# 10GBASE-T start up: new concepts and proposed text

Gottfried Ungerboeck, Broadcom Corporation

Figure 55-aa—Interaction between Auto Negotiation and PHY Control

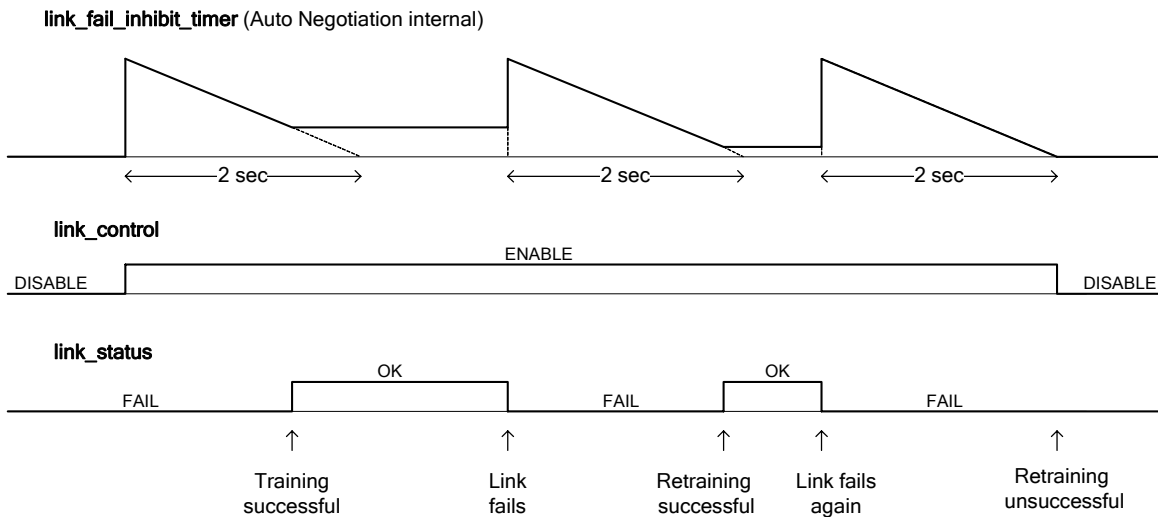
*[By observing `link_status`, Auto Negotiation can determine the length of initial training periods and the length and frequency of retraining events. Several possible uses of this information are conceivable.]*

Assertion of  $link\_control = DISABLE$  by Auto Negotiation forces PHY Control unconditionally into state PHY\_Disabled. In state PHY\_Disabled, the PHY is silent, signals  $link\_status = FAIL$ , and waits for being enabled by Auto Negotiation.

When Auto Negotiation sets `link_control = ENABLE`, PHY Control begins the PMA training process. AutoNegotiation also starts the internal `link_fail_inhibit_timer` at a nominal value of 2 sec. PHY Control is given this maximum time to reach state `PCS_Data`, where it sets `link_status = OK`. *[When Auto Negotiation observes `link_status = OK`, it may stop the `link_fail_inhibit_timer` or let it continue to count down to zero and stop there.]*

During normal PHY operation in state `PCS_Data`, a failure situation may occur causing PHY Control to return to state `Silent`, set `link_status = FAIL`, and then begin PMA retraining. When Auto Negotiation observes the transition of `link_status` from `OK` to `FAIL` while `link_control = ENABLE`, the `link_fail_inhibit_timer` is restarted at a nominal value of 2 sec. *[or a smaller value for retraining?]* This gives PHY Control another opportunity to reach state `PCS_Data` within this maximum time.

When the `link_fail_inhibit_timer` has counted down to zero and PHY Control has not yet signaled `link_status = OK`, Auto Negotiation sets `link_control = DISABLE` and thus forces PHY Control to return to state `PHY_Disabled`.

**Figure 55-bb—InfoField format and payloads**

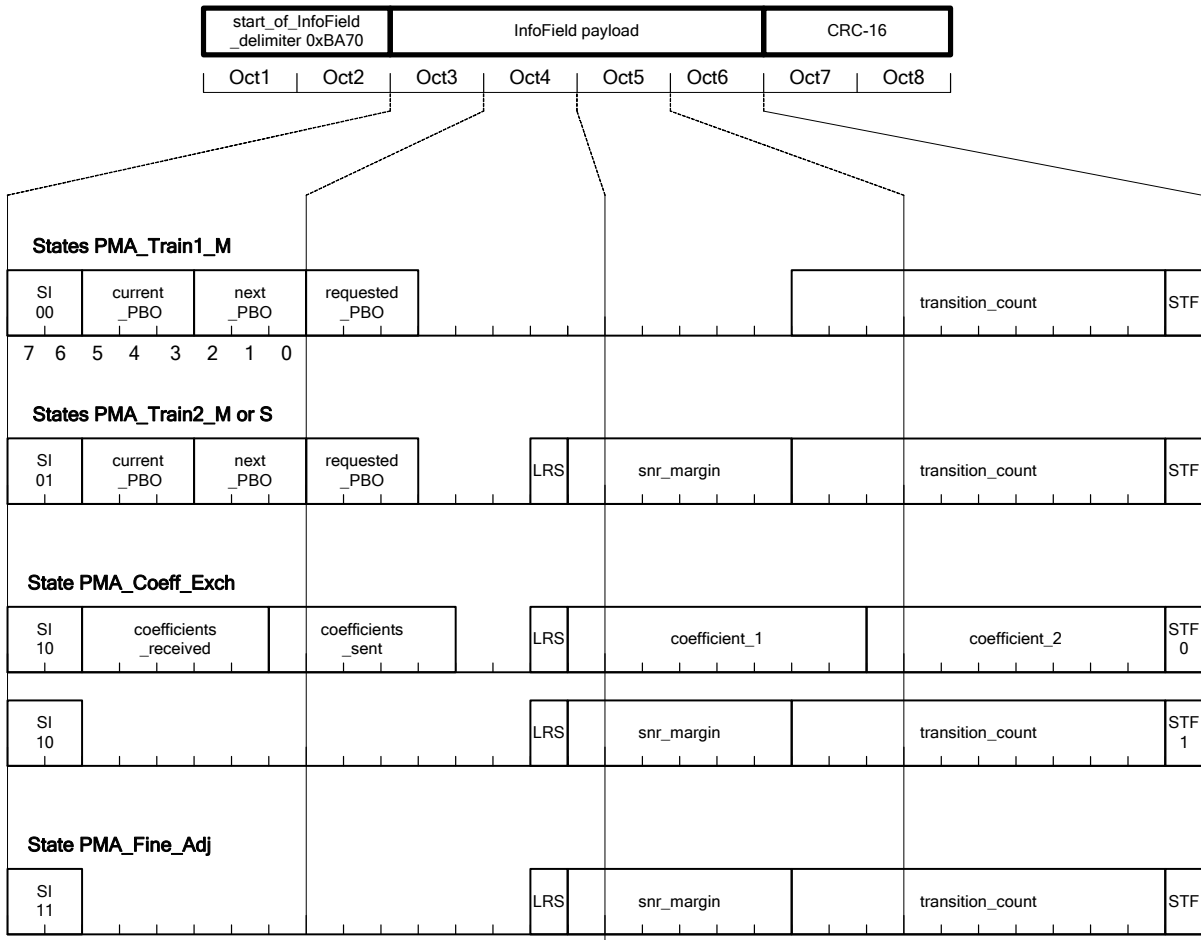
*[ In some implementations, the resources required to decode an InfoField will be proportional to the length of the InfoField. This provides one motivation to shorten the InfoField from 16 octets as in Draft 2.2 to 8 octets ( or even smaller length). Avoiding wasteful use of bit positions and redundancies as in the InfoFields of Draft 2.2 is another reason. ]*

[Notice that there are no fields  $THP \in \{THP_{Byt}, THP_{Short}, THP_{Med}, THP_{Long}\}$ . The specification of these fields in the InfoField format of Draft 2.2 is redundant and hence not needed. If fixed precoding is requested for the transmission of PMA training frames in states PMA\_Train1\_M and PMA\_Train2\_M (corresponding in Draft 2.2 to state PMA\_Training\_Init\_M) and state PMA\_Train2\_S (corresponding in Draft 2.2 to state PMA\_Training\_Init\_S), the value of THP is implied by the value of PBO; see Draft 2.2, section 55.4.2.5.11: PBO = 7 implies THP = THP<sub>Short</sub>, PBO = 5 implies THP = THP<sub>Med</sub>, PBO = 3 implies THP = THP<sub>Long</sub>].

The InfoField and its state dependent payloads are depicted in Figure 55-bb. The InfoField comprises 8 octets. The first two octets provide a `start_of_InfoField_delimiter` (Oct1:2), which contains the hexadecimal value 0xAB70, i.e., the binary sequence 1010101101110000 *[or whatever]*. The next four octets convey the InfoField payload (Oct3:6), which is checked by a 2-octet CRC-16 (Oct7:8). Unused bit positions in the payload may be set in the transmitter to arbitrary values and are ignored upon reception.

Figure 55-cc— PHY Control state diagram and relation with Auto Negotiation

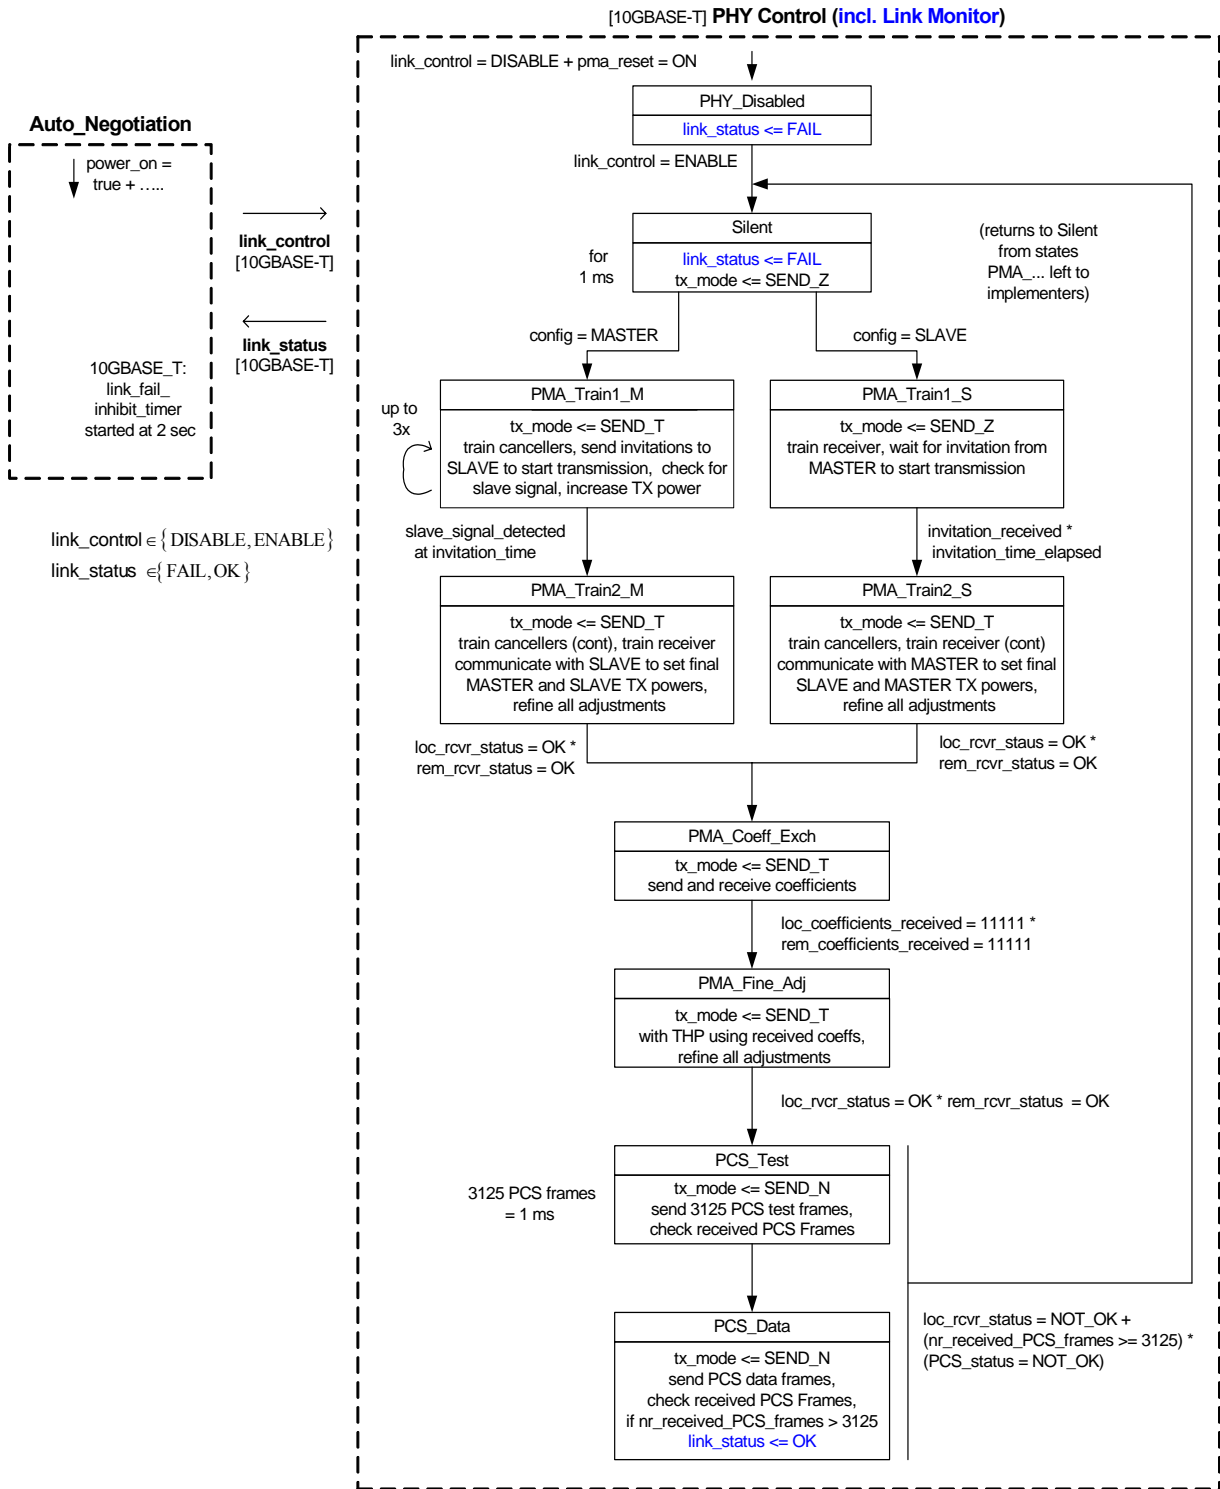
*[Section 55.3 in Draft 2.2 should define the effect of link\_status on the PCS RECEIVE and PCS TRANSMIT functions. This author has not found this definition. Where is it?..... ]*

When Auto Negotiation sets `link_control` from `DISABLE` to `ENABLE`, PHY Control proceeds from state `PHY Disabled` to state `Silent`.

In state `Silent`, the PHY remains silent (`tx_mode = SEND_Z`) for a fixed period of 1 ms. Then, if `config = MASTER`, PHY Control enters state `PMA_Train1_M`. Otherwise, `config = SLAVE` and PHY Control enters state `PMA_Train1_S`.
